From: Mark Warwick
Sent: 29 January 2019 15:11
To: Charlotte Easton
Cc: Planning.Responses
Subject: AL/109/18/T

Planning Application Ref: AL/109/18/T

Location: 16 Woodgate Road, Woodgate, Aldingbourne, PO20 3SX

Description of works: Reduce or remove branches as necessary to achieve a maximum of 2m building clearance and 4m overhead clearance above side of property (driveway and garden areas) to 2No. oak trees. Reduce or remove branches as necessary to achieve a maximum of 3m overhead clearance above driveway to 1No. hawthorn.

Figure 2 Positions of final cuts

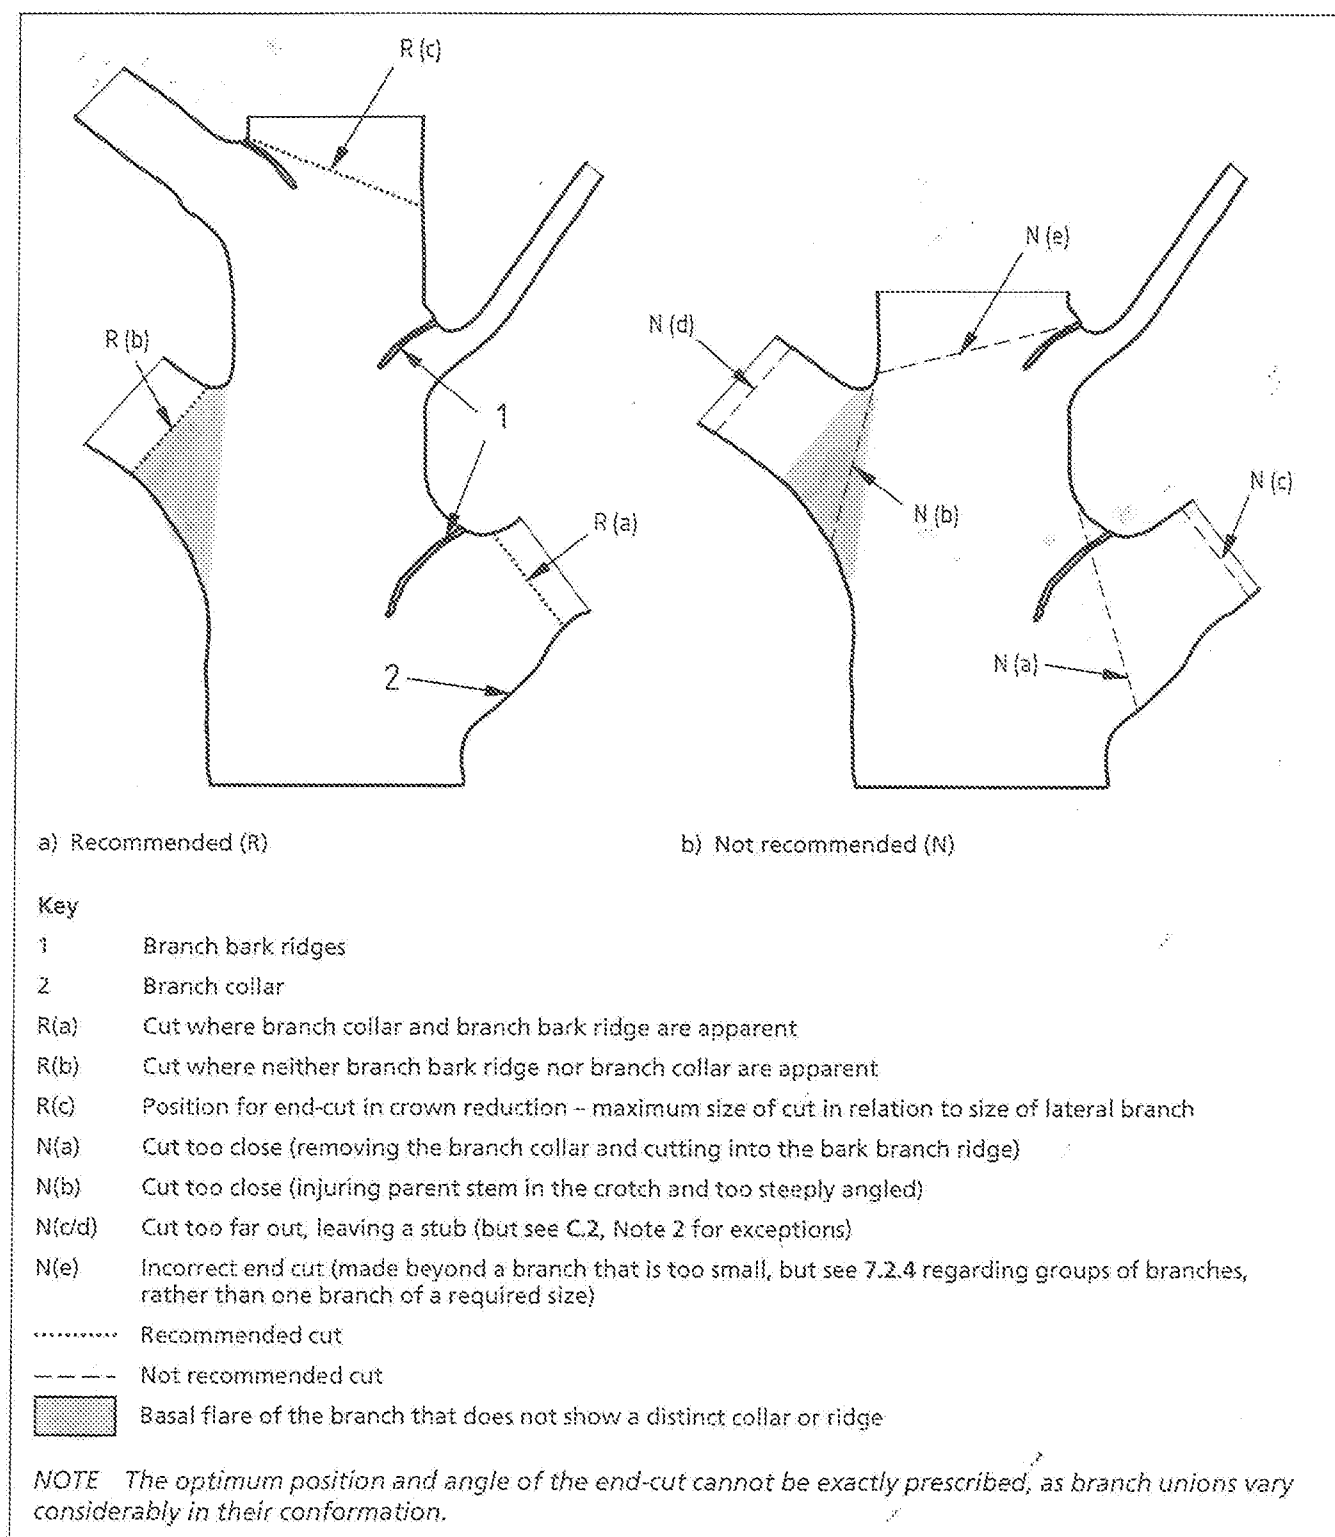
- Where whole branches are to be removed and final cuts made close to the trunk or branch union they are to be made as shown in Figure 2 of BS3998:2010
- Where branches are to be shortened back the final cuts are to be made at the correct angle shown in BS3998:2010 and adjacent to a live bud or lateral.
